Technical Bulletin Number: TB116099

Technical Bulletin Title: LFPS2 Retrofit Kit for STERRAD® 100S Sterilizers

Technical Bulletin Number: TB117299 Date: 6/18/02

Technical Bulletin Title: STERRAD® 100S Software Upgrade

Figure 1

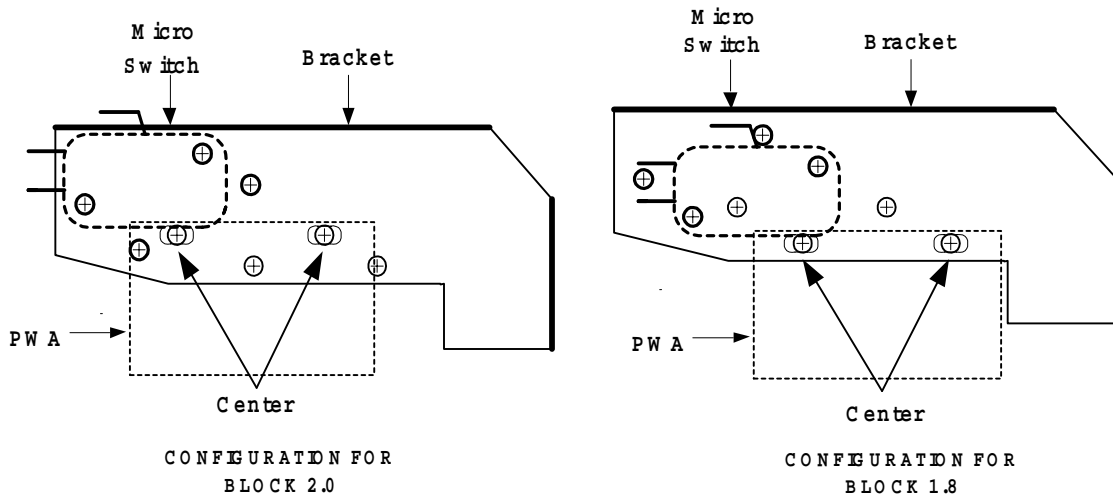
25. From the LFPS2 KIT, STERRAD® 100S, USA (05-50559-0-002), Sensor/Safety switch assembly, Door, Top (03-50409-1-001), locate the bracket (31-50401-001) and the PWA, Sensor, Door (04-00975-001). Assemble the PWA on to the Bracket using two M3 x 6mm screws and flat washers supplied in the kit. Make sure that the mounting screws are centered on the mounting slots of the PWA, and it is in the proper location for the machine version (block 1.8 or 2.0) as depicted in figure 1.

26. From Sensor/Safety switch assembly, Door, Top (03-050409-1-001), mount the Micro Switch (57-50410) on to the bracket using two M2.5 x 25mm screws supplied in the kit. Make sure the switch is mounted in the appropriate location for the machine version (Block 1.8 or 2.0). See figure 1.
27. Loosen the two M4 x 8mm mounting screws for the Door Flag (ASP P/N 31-01082-001), located at the bottom left of the door assembly.
28. Install the grommet shim, ASP P/N 63-01441-102 on to the top of the door flag. Position the grommet shim such that both ends of the door flag, and the grommet shim are even with one another. See figure 2.

Figure 3

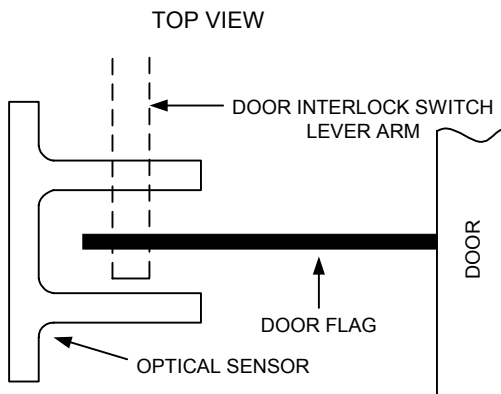
29. Mount the completed Sensor/Safety switch assembly loosely to the left guide rail using two M4 X100mm screws.
30. Position the bracket so that the door flag is centered inside the optical sensor, and clear of the path of the door. Align the bracket so that the end of the flag is not touching the back of the sensor body. Tighten the two M4 mounting screws. See figure 3..

Figure 4

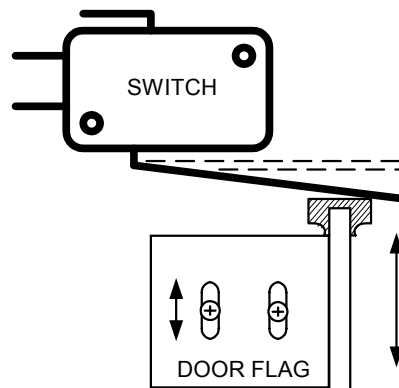
31. With the door still closed, slide the loosely positioned door flag upward between the optical sensor until the flag is contacting the interlock switch moment arm. Continue to slide the flag upward until an audible click from the switch is heard (switch engaged), and the moment arm of the switch is at the end of it's travel. Tighten the two M4 x 8mm screws. Ensure the flag is positioned perpendicular to the door in both axis, and that the flag is centered between the optical sensor. Readjust if necessary. See figure 4.

Figure 5

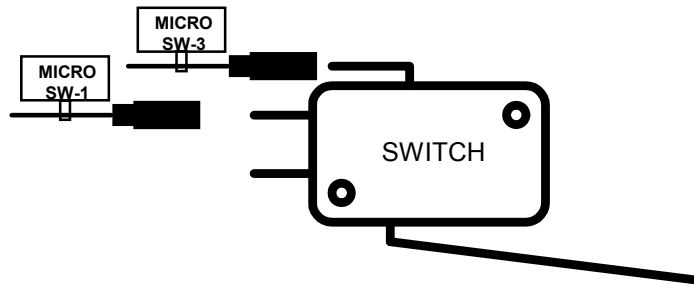
39. Connect J44 back to the optical PWA.
40. Connect the quick connect marked Micro SW-3 to the switch COM contact. See figure 5.
41. Connect the quick connect marked Micro SW-1 to the switch N.O.3 contact. See figure 5.
